**FIRE SERVICE LINE
 to serve
 2054 CUSTER
 LOT 1 BLK 4
 SOUTHWEST INDUSTRIAL ADD.
 CITY OF WICHITA, KANSAS**

**Gary Janzen, P.E. City Engineer
 Project Number
 1959 PPW (607853)**

AS BUILT PLANS
 Contractor: McCullough Excavation
 Inspector: Dakota Zimmerman
 Ruggles & Bohm
 PDF Made By: DGZ 03/08/2016

RUGGLES BOHM
 PROJECT NUMBER: _____
 DRAWING FILE: _____
 DESIGN: RACMB
 DRAWN: RA
 UTILITY
 DATE: Jan. 14, 2016
 REVIEW: _____
 RB JOB: 4460E
 SHEET: 4 OF 10
**BRACE BUILDING 2
 FIRE SERVICE
 WICHITA, KANSAS**

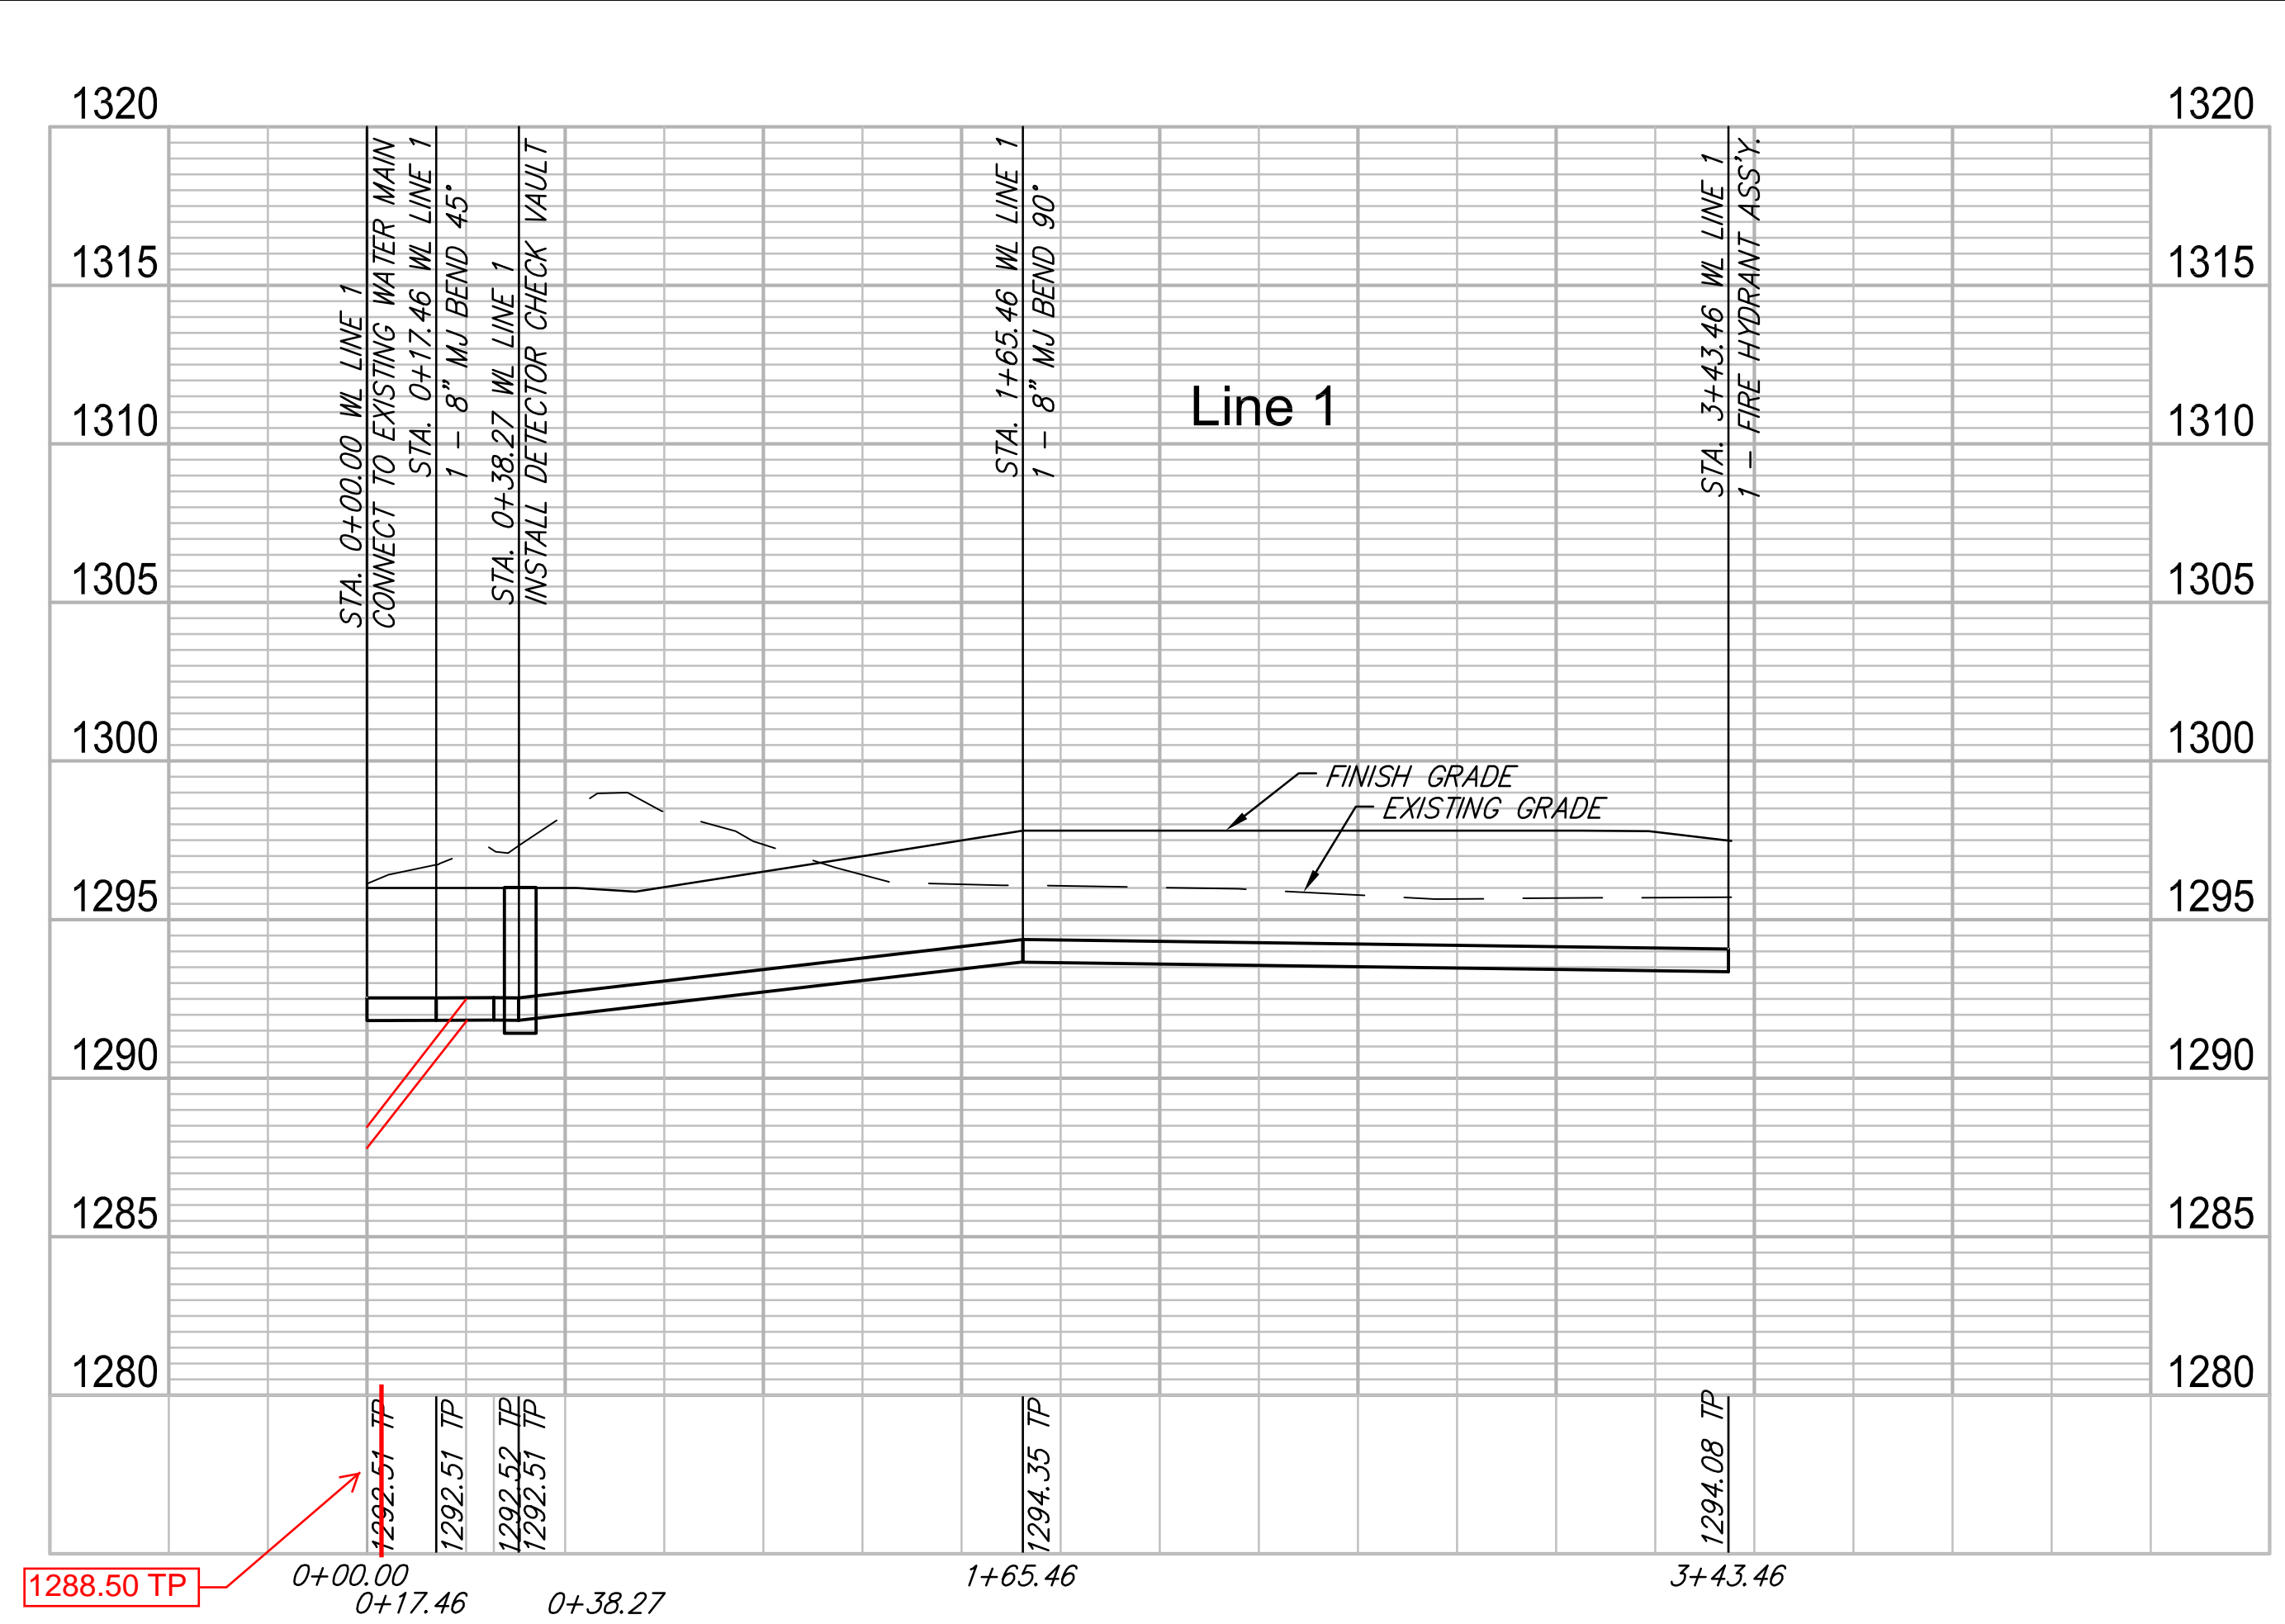
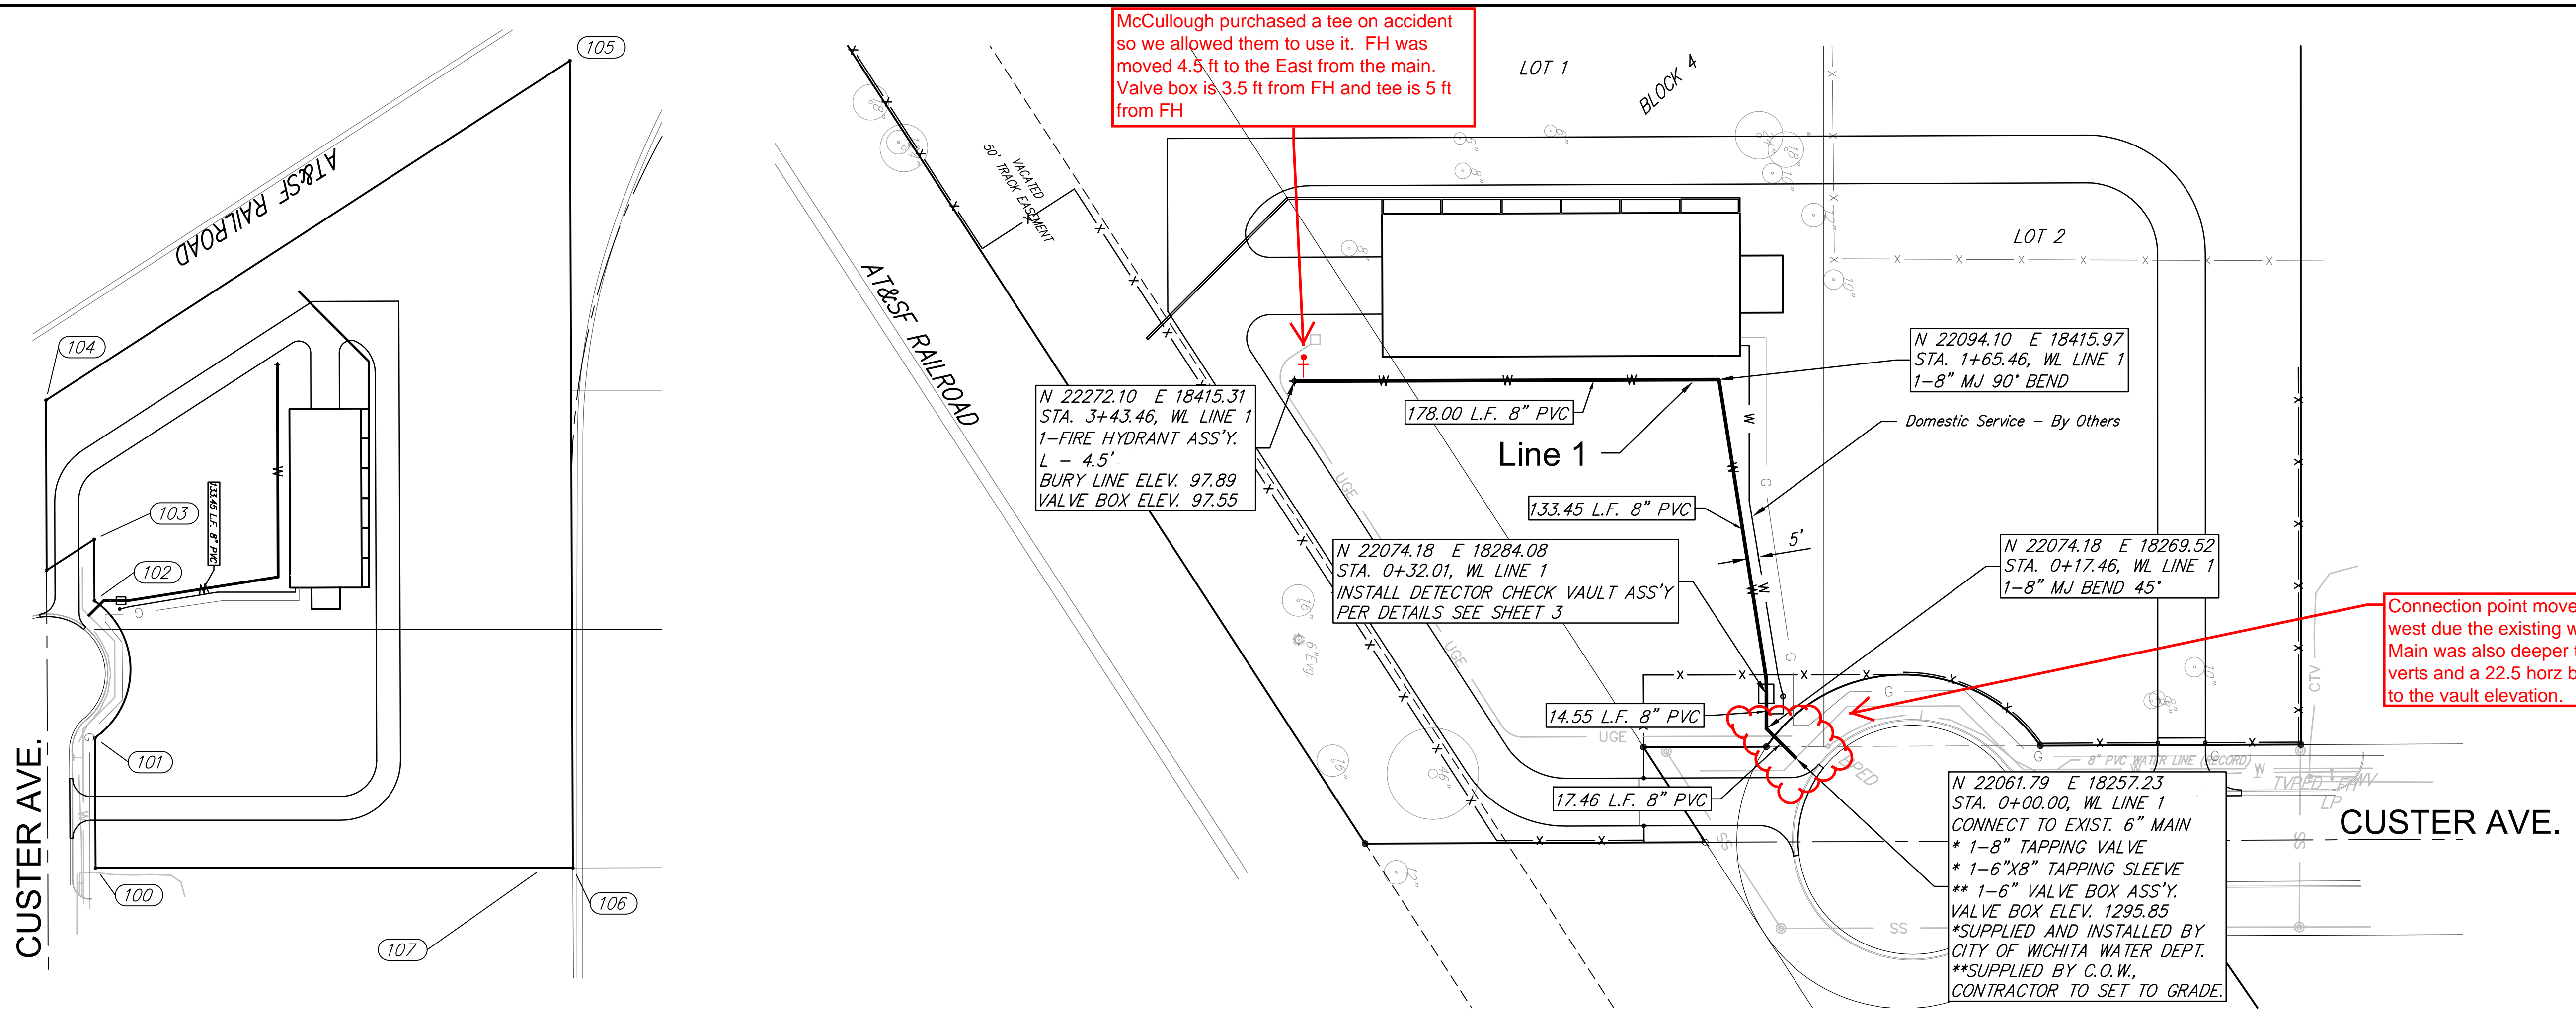
McCullough purchased a tee on accident so we allowed them to use it. FH was moved 4.5 ft to the East from the main. Valve box is 3.5 ft from FH and tee is 5 ft from FH

Connection point moved 4.0 ft to the south west due the existing water main bell location. Main was also deeper then planned. Two 45's verts and a 22.5 horz bend was used to get up to the vault elevation.
